Docket Number:	09-AFC-07C
Project Title:	Palen Solar Power Project - Compliance
TN #:	201422
Document Title:	Letter Regarding Update on Morongo Basin Conservation Association Response to CEC Letter (12/6/2013)
Description:	N/A
Filer:	Alicia Campos
Organization:	Morongo Basin Conservation Association
Submitter Role:	Public Agency
Submission Date:	12/12/2013 2:49:35 PM
Docketed Date:	12/12/2013

Re: Update on MBCA response to CEC letter (12/6/2013) regarding PSEGS conflicting power tower dimensions between the CEC-FSA (Docket # 09-AFC-07C) and the BLM-DEIS (CACA #048810)

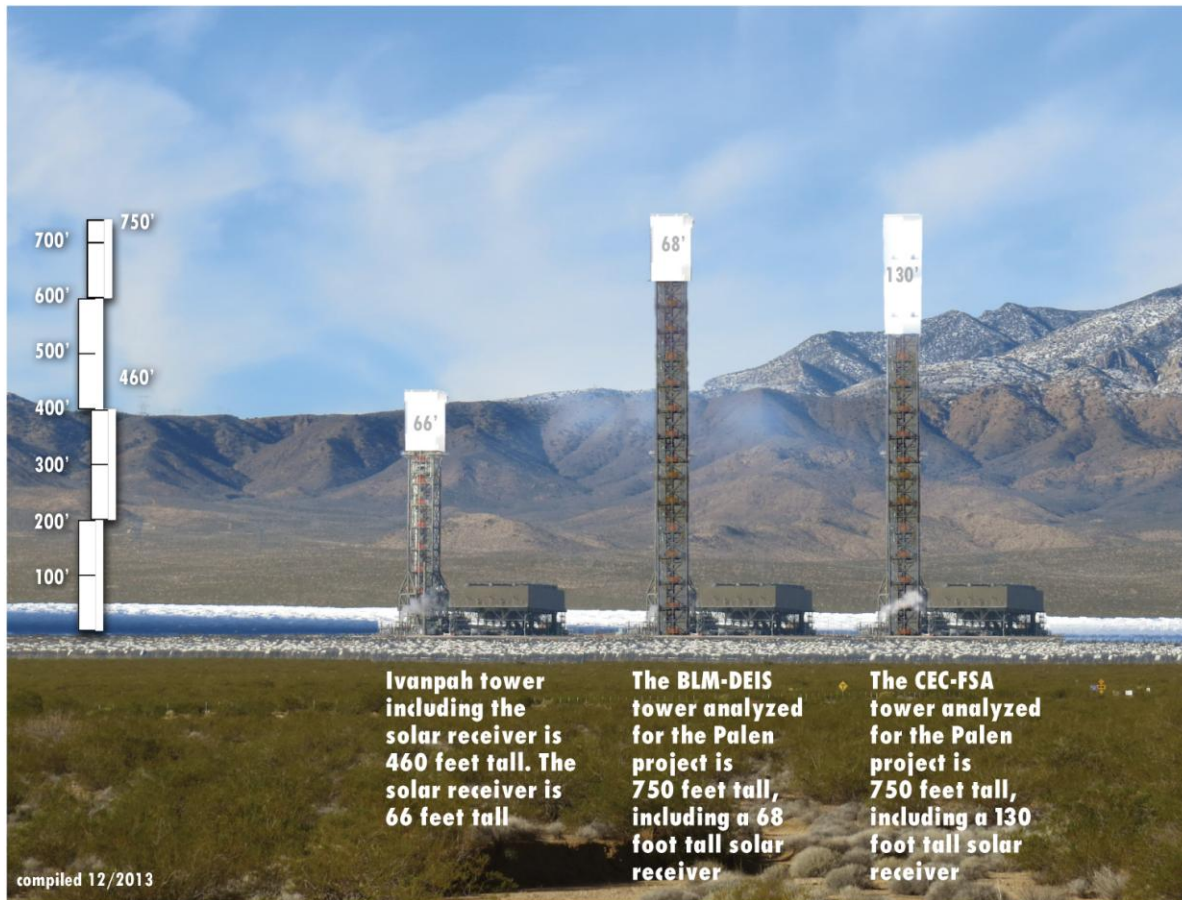
In the interim it was suggested that a visual would assist the reader in understanding the magnitude of the discrepancy in the height of the solar receivers included in the towers analyzed for the CEC-FSA and BLM-DEIS. The table below recaps the discrepancy and the following visual displays the difference, assuming CEC analyzed a 750-foot tower, as explained in Martin-Gallardo letter. (Note: The Ivanpah lattice tower was used for reference. The Palen towers are described as solid concrete.)

MBCA and the public want to know which of the two solar receivers will win out. Which agency gets to start over?
